Access Report

**Collaroy Living Residences**  
37-43 Hay Street  
COLLARROY NSW

For: Collaroy Living Pty Ltd  
Ref: LP\_22521

Development application documentation for the proposed seniors living development – Collaroy Living Residences – located at 37-43 Hay Street Collaroy has been reviewed against current and applicable accessibility legislation.

Figure 2 | Overall Site Plan

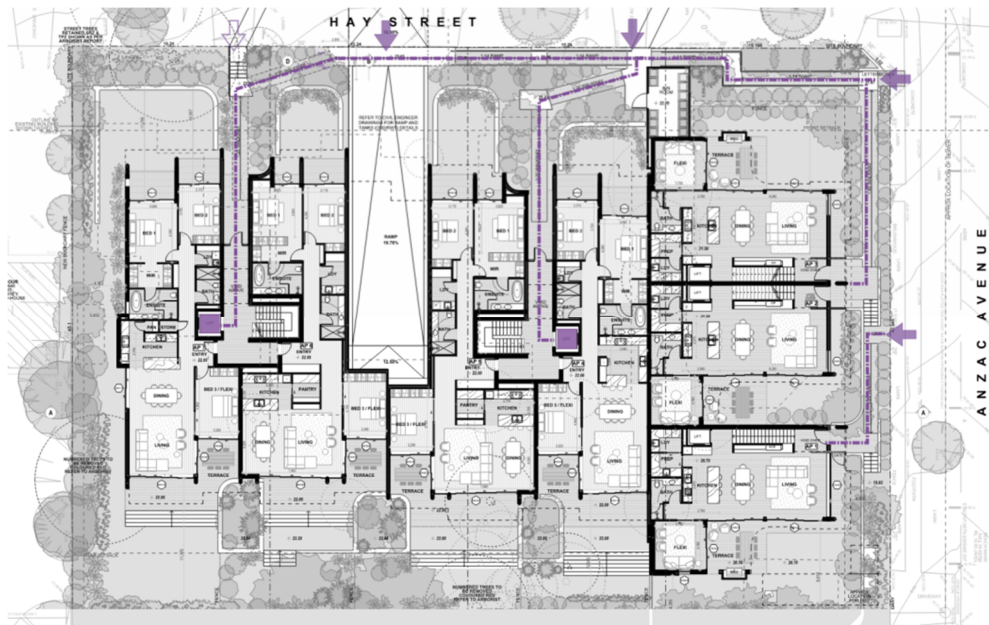
In this instance, the approach to the building has been considered as follows:

- from the allotment boundary at the pedestrian entrance along Hay Street and Anzac Avenue to the building entrance
- from the carparking area to the building entrance.
